# Access Compliance Report

## Public Rights-of-Way

| Intersection ID: 15175                  | Main Street: SOUTH_BV | Cross Street: POINDEXTER_DR             | Location: W            |
| ADA ID: 56EC304A14A5                    | Ramp Type: Perp       | Initial Pass/Fail: Fail                 | Overall Compliance: No |

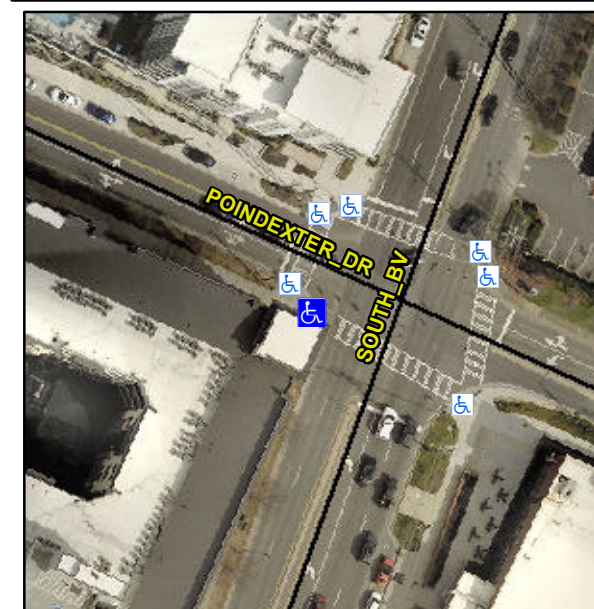
**Not Found, R304.5.1, R304.2.2**

| Compliance | Description           | Data  | Compliance | Description                 | Data |
|------------|-----------------------|-------|------------|-----------------------------|------|
| N/A        | Ramp Length (in)      | 96.0  | No         | Ramp Slope (%)              | 10.0 |
| No         | Ramp Width (in)       | 46.0  | Yes        | Ramp XSlope (%)             | 1.6  |

**Remove & Replace Entire Ramp.**
